**DEPARTMENT OF PLANNING AND
COMMUNITY DEVELOPMENT**

CASE NO.: 98-CUP-012 (Lighting Plan)

REQUEST: Request for approval of an exterior lighting plan for an office complex.

AGOURA HILLS CORPORATE POINT
 30200 & 30300 AGOURA ROAD
 AGOURA HILLS, CA

EXHIBIT B

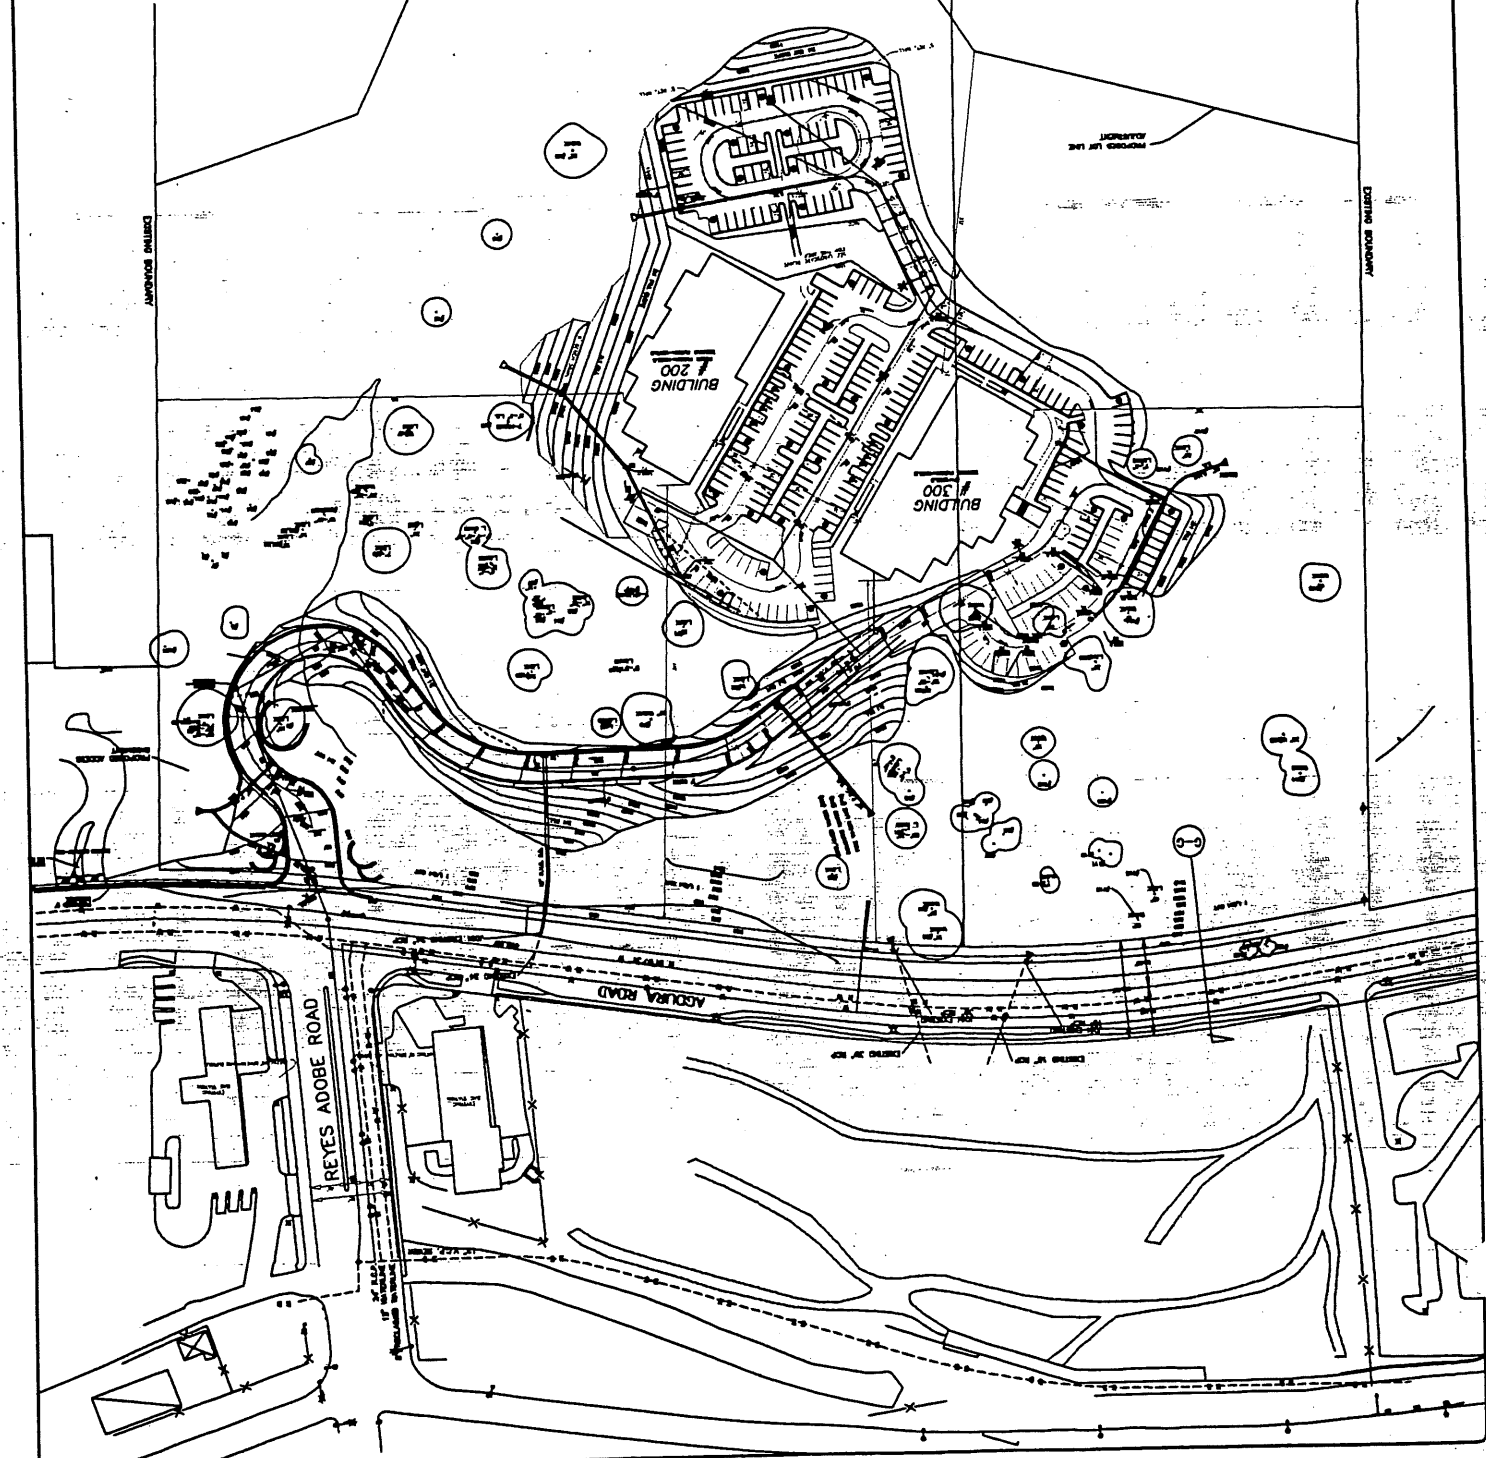
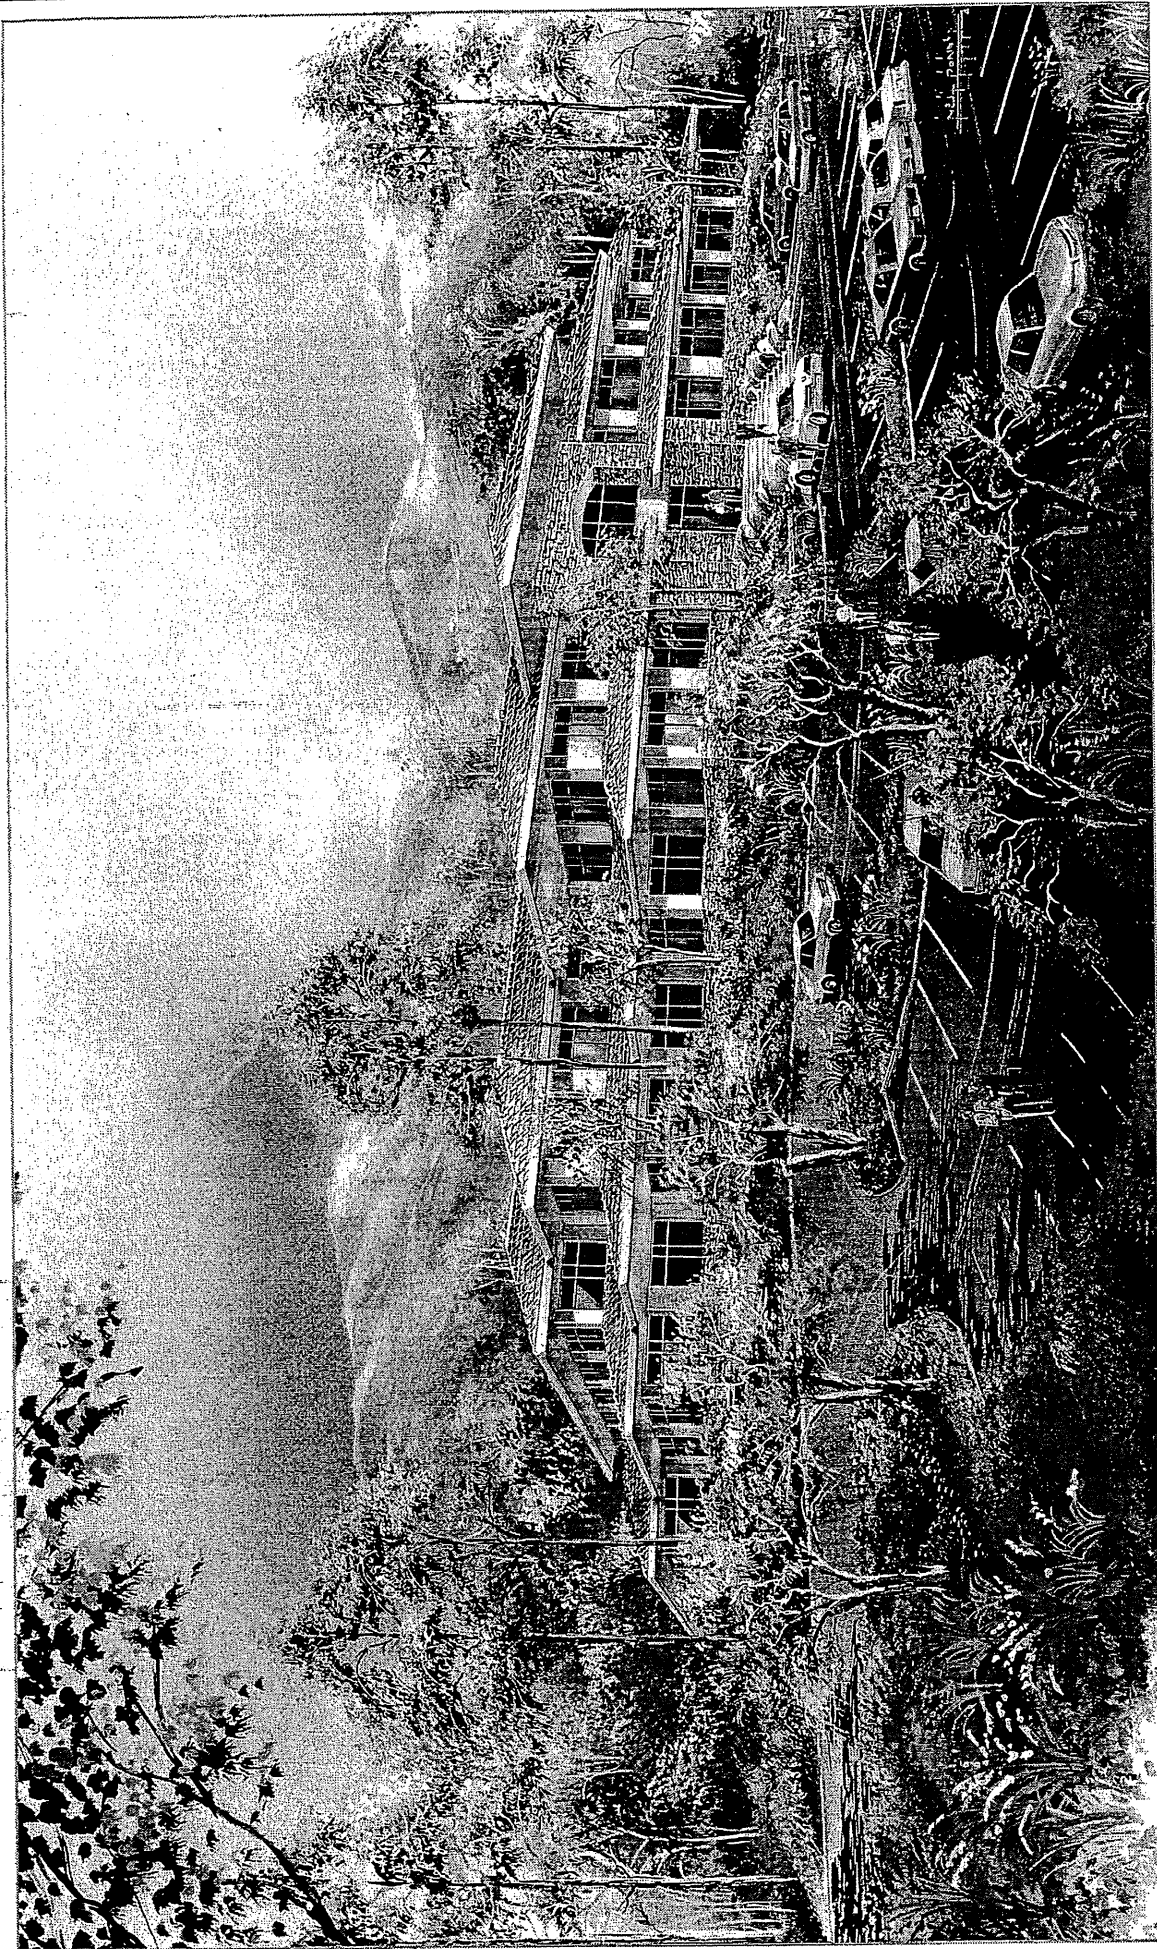
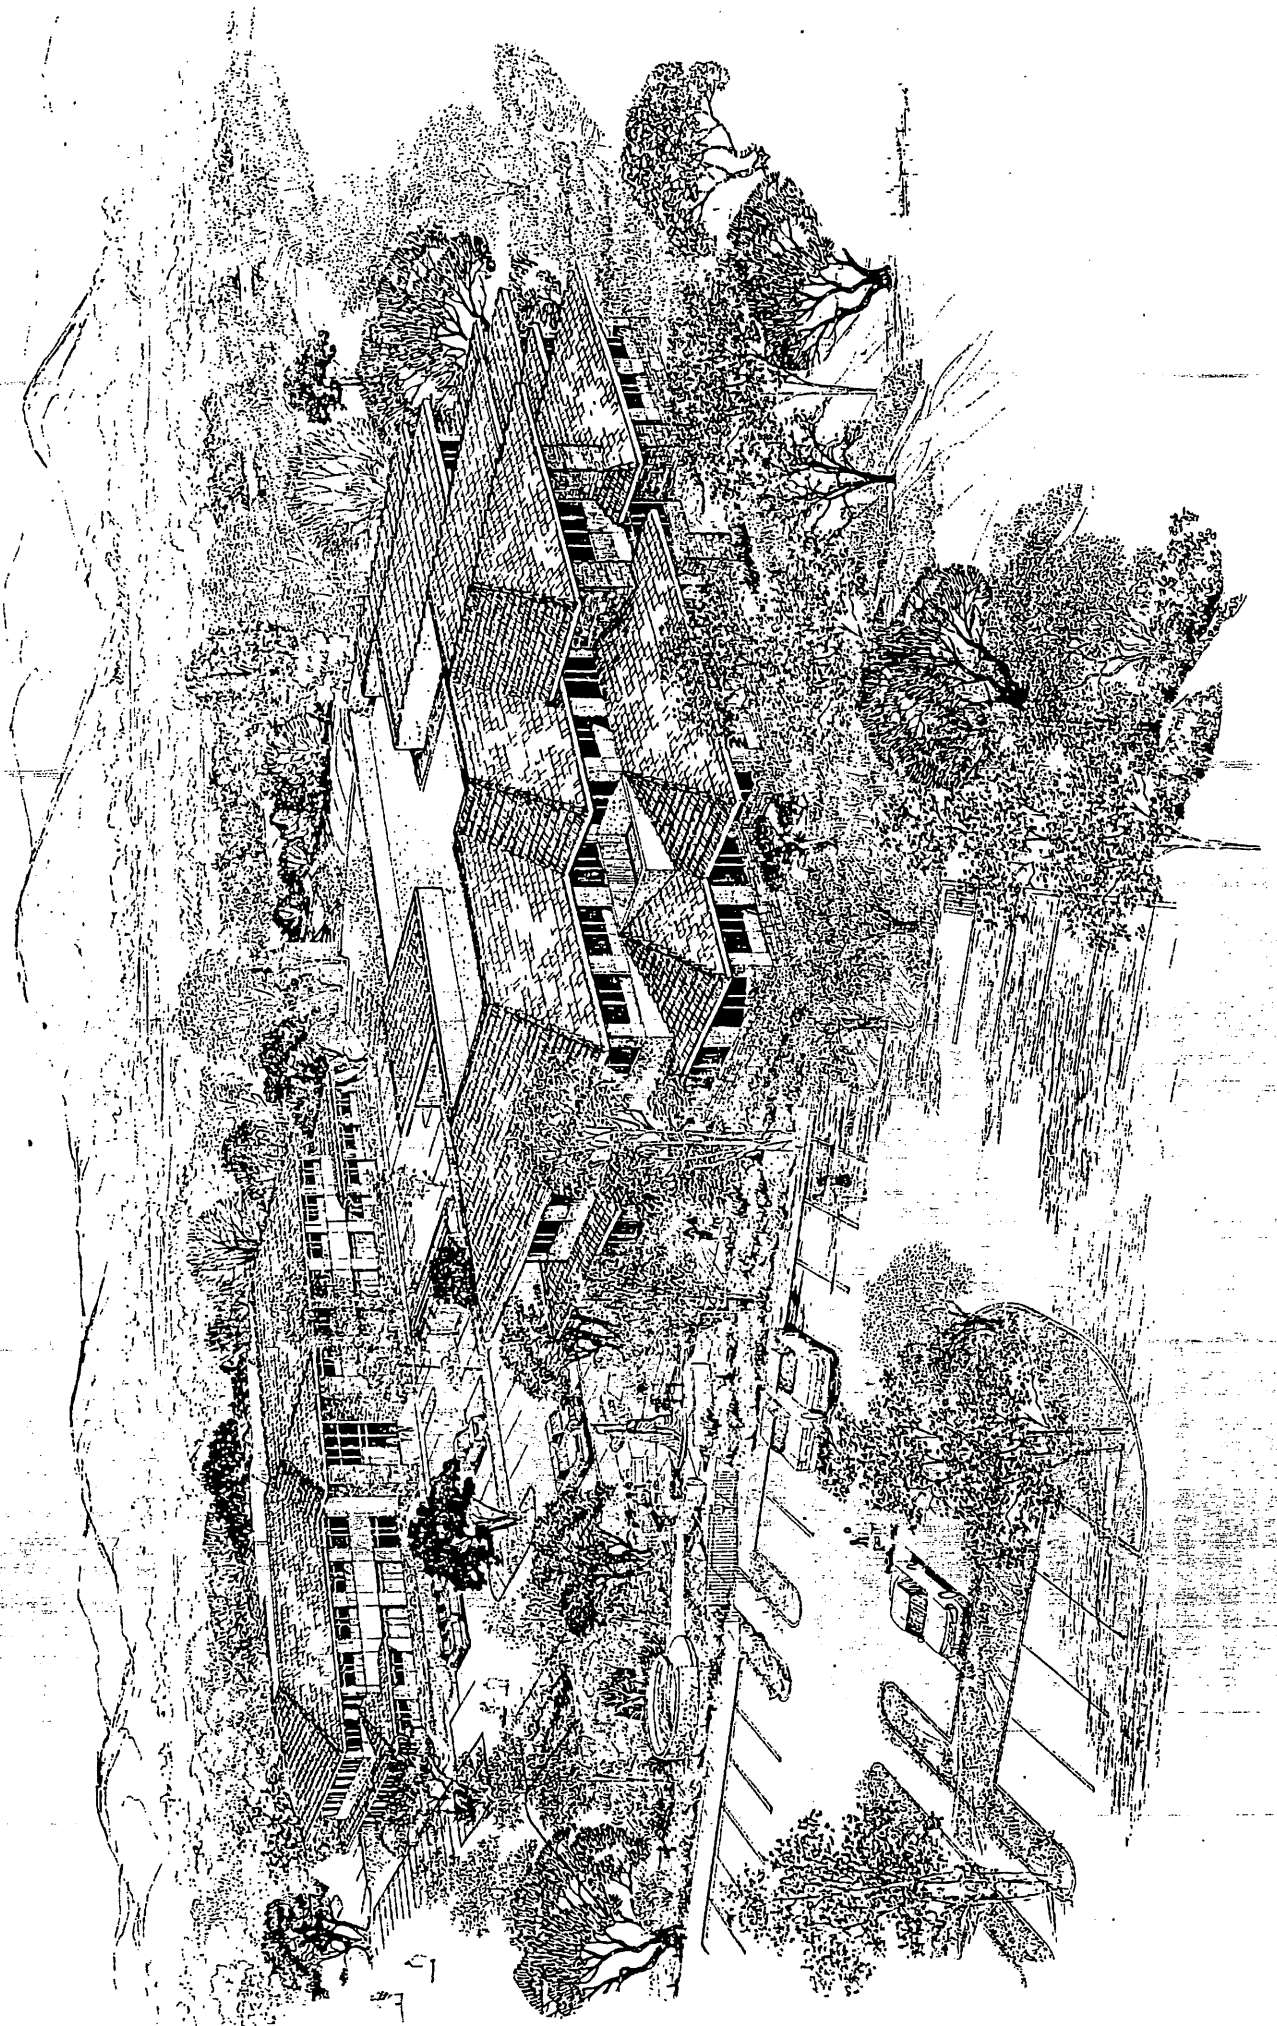
The project is currently in building and grading plan check with the Building and Safety Department. The applicant has submitted a lighting plan for the Planning Commission's review that includes proposed exterior light fixtures for the project's parking lots and drive-aisles. Each proposed fixture is circular in shape with a cutoff lens that is flush with the bottom of the fixture. All proposed fixtures and support poles include a bronze finish that is intended to be compatible with the building. Staff recommends that the cement mounting base of each fixture pole be stuccoed and painted to either match the color of the light fixtures or the building. The maximum height allowed by the City for each fixture, including the mounting base, is 16 feet.

The applicant is also proposing metal halide illumination for the fixtures. While the metal halide illumination is energy efficient, the Planning Commission has the discretion to require an even more efficient source of light emitting diodes (LED), if it is deemed more appropriate for the project. No wall mounted fixtures are proposed for this project since they are specifically prohibited in the project's conditions of approval.

Staff finds the proposed lighting plan to be in compliance with the City's Lighting Standards and Guidelines, as well as with the design of the office project. The Lighting Standards and Guidelines call for exterior lighting to be "sensitive to the character of the surrounding neighborhood to reduce negative visual impacts and glare onto residential neighborhoods, the freeway corridor, and public areas. Proximity to hillside areas, park land, rural or other similar areas will also require increased sensitivity to use exterior lighting. Areas of sensitivity may require more subtle lighting. Illumination levels shall not exceed one (1) footcandle at the property lines, measured at ground level. However, pedestrian areas and areas near the building that are accessible to the public and not clearly visible from the street or parking lot should be appropriately illuminated for public safety." The Lighting Standards and Guidelines also call for parking lot lighting to be "designed or selected to compliment the architecture of the building, and provide the minimum safe lighting levels. The required parking lot lighting plan shall be prepared with an understanding of the business hours of operation, as well as the intention to minimize lighting levels when the building is not occupied."

Since the property is within an environmentally sensitive hillside area, with adjacent designated open space land, it is important that the exterior lighting not be imposing. Toward that end, the applicant is proposing light fixtures strictly within the parking lots and drive-aisles. The illumination levels will not exceed one footcandle at the property lines. The project will be prominently visible as the building pads will be higher than any commercial building in the city. In order to retain and ensure the semi-rural ambience of this area of the City and to reduce negative visual impacts within the freeway corridor, it is recommended that the actual illumination levels of all lighting fixtures be subject to field review and approval by the Director of Planning and Community Development upon installation. It is further recommended that exterior illumination levels be reduced by at least 50% at times when the office complex is closed.

8. The parking lot light poles and fixtures shall not exceed 16 feet in height, including the mounting base. The mounting base shall be stuccoed and painted to either match the light fixtures or the buildings.
9. Landscape/garden lights, if proposed, shall be subject to review and approval by the Director of Planning and Community Development upon approval of the project's final landscape plan.
10. Roof-mounted and/or roof parapet-mounted lighting is prohibited.

11. Exterior illumination levels shall be reduced by at least 50% at times when the office complex is closed.
12. The actual illumination levels of all exterior lighting fixtures shall be subject to field review and approval by the Director of Planning and Community Development, and the lighting may be subject to reduced illumination levels if determined to be necessary for compliance with the City Lighting Standards and Guidelines.
